Addendum 1

Project: Fairland Community Center
Project Number: 20210121.76
Date: October 14, 2025
Addendum Number: 1

ADDENDUM 01 – FAIRLAND COMMUNITY CENTER

FAIRLAND COMMUNITY BUILDING

B 102 S
1/4" = 1'-0"

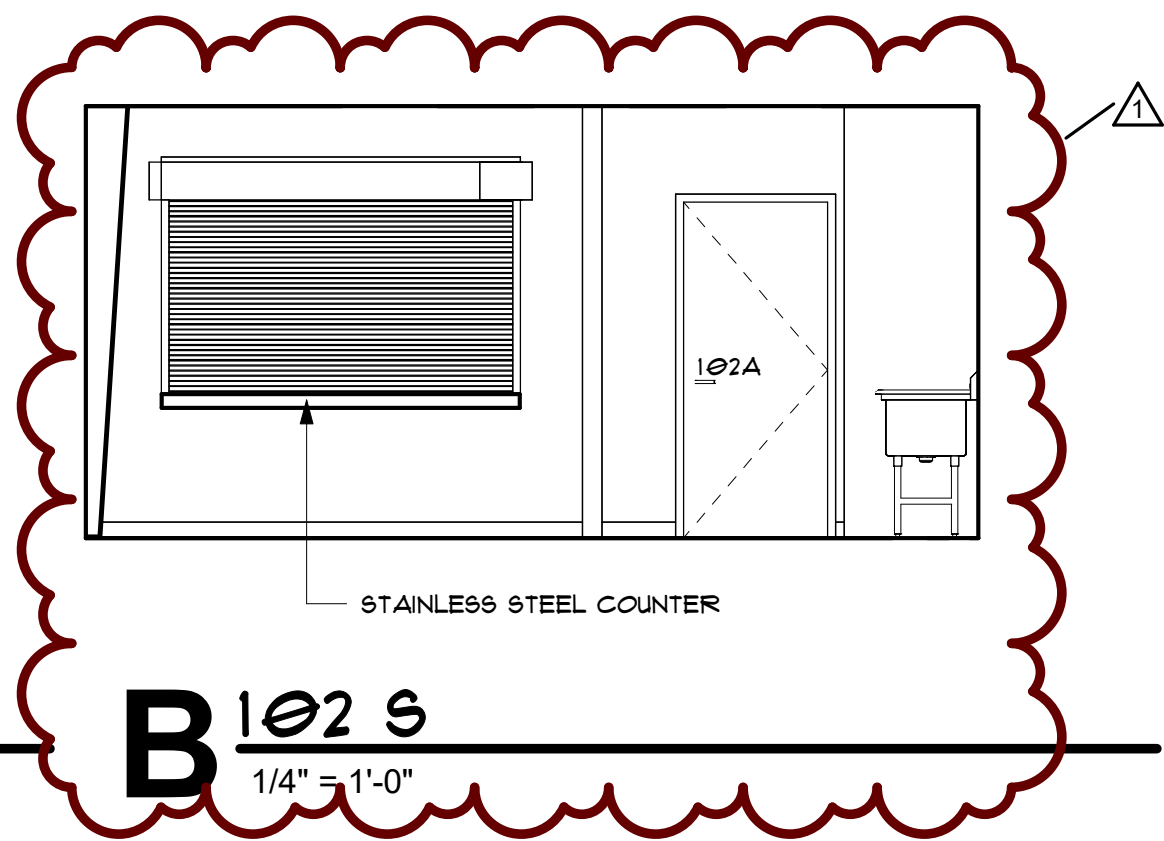
- 1. Sheet CS COVER SHEET**
 - 1.1 Added Sheet G005
- 2. Sheet G005 SPECIFICATION**
 - 2.1 Sheet Added
- 3. Sheet A401 ENLARGED PLAN AND ELEVATIONS**
 - 3.1 Revised Detail B
 - A. Called out Stainless Steel counter and door height.
 - 3.2 Updated Interior Elevation General Notes
- 4. Sheet A402 ENLARGED PLAN AND ELEVATIONS**
 - 4.1 Updated Finish Legend
 - A. Floor Tile has changed to Chi-Town The Loop
- 5. Sheet A611 DOOR SCHEDULE AND DETAILS**
 - 5.1 Door Types updated
 - 5.2 Door Schedule updated

2. WHAT IS THE INTENDED COUNTERTOP MATERIAL AT THE COILING DOOR IN KITCHEN 102?

ANSWER: Stainless Steel

A ENLARGED PLAN
3/8" = 1'-0"

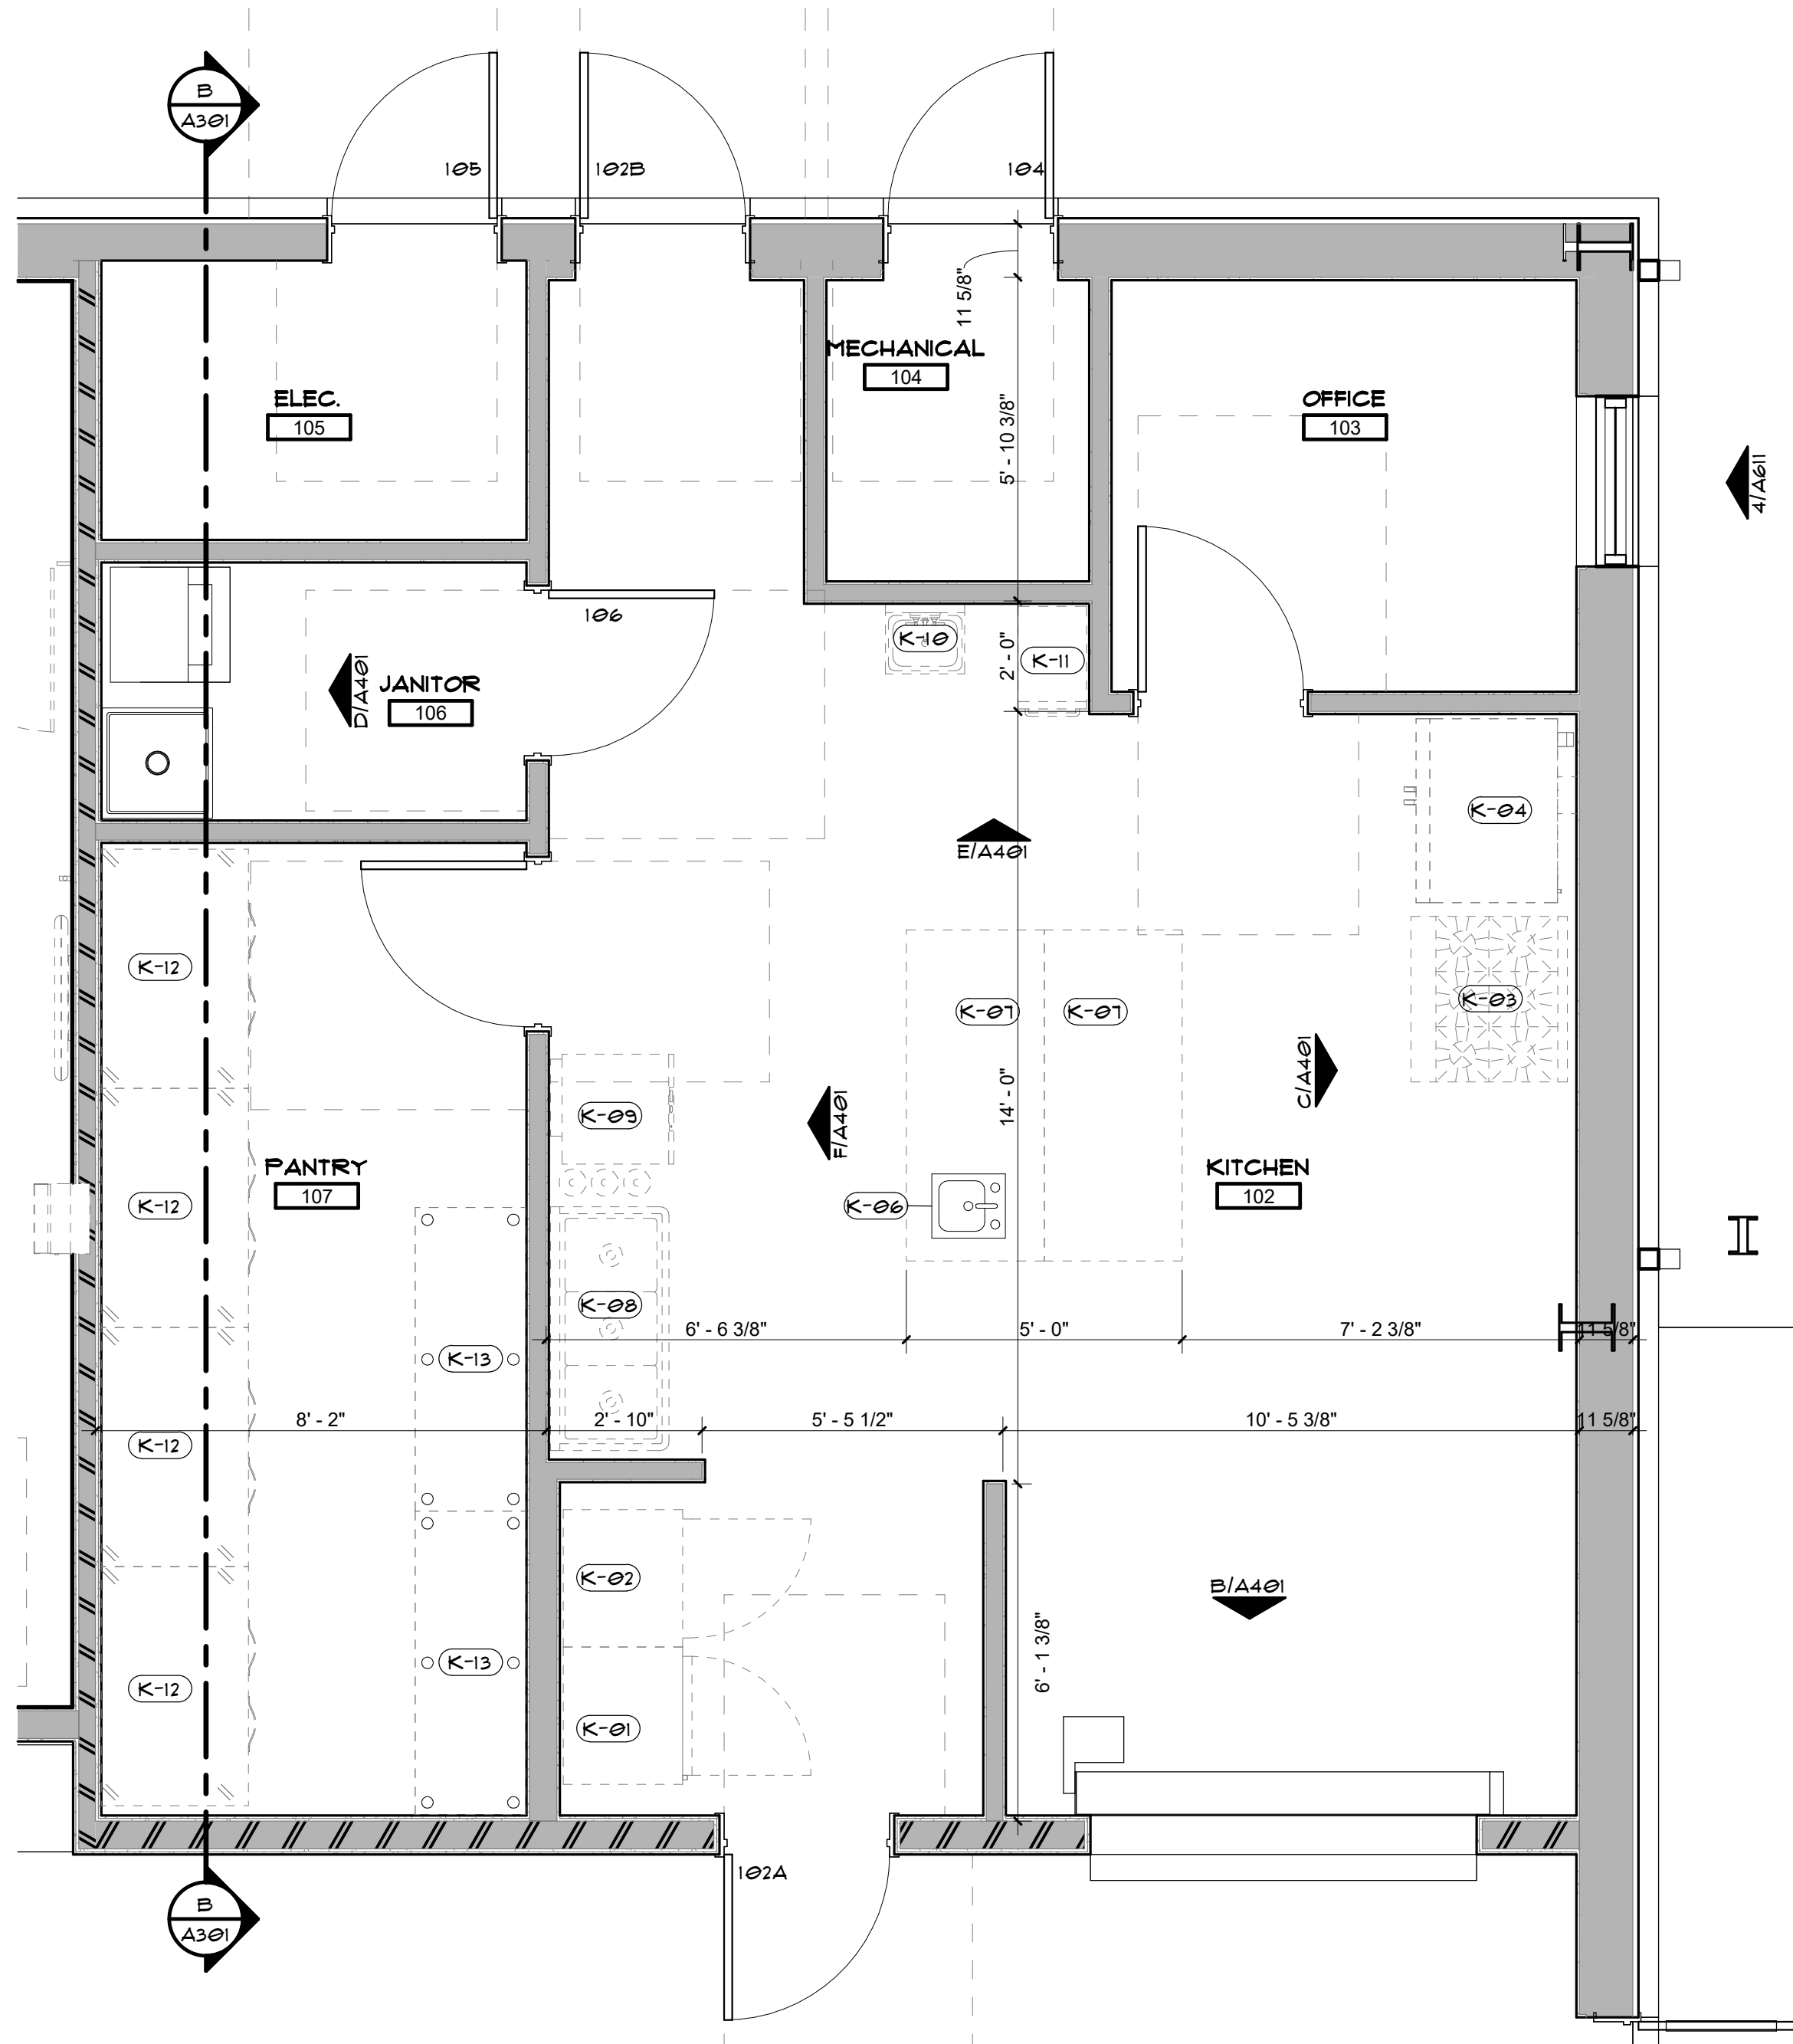
11. Kitchen schedules — P300 (K02 Vulcan range, K03 Hobart LXGnR, K04 Bunn, KS-1) conflicts with A401 (different range, double oven, prep sink, 3-comp, Hobart LXnR). Which governs? Where does the dishwasher connect, and how does it get 140°F HW when WH-1 is set at 120°F?

14. There is a kitchen with no equipment list as on the specs. Can you put me in contact with who is in charge of purchasing the kitchen equipment?

ANSWER: Schedule on A401 governs. WH-1 is set to 140

ANSWER: Equipment list is on sheet A401. All kitchen equipment is to be contractor furnished and installed.
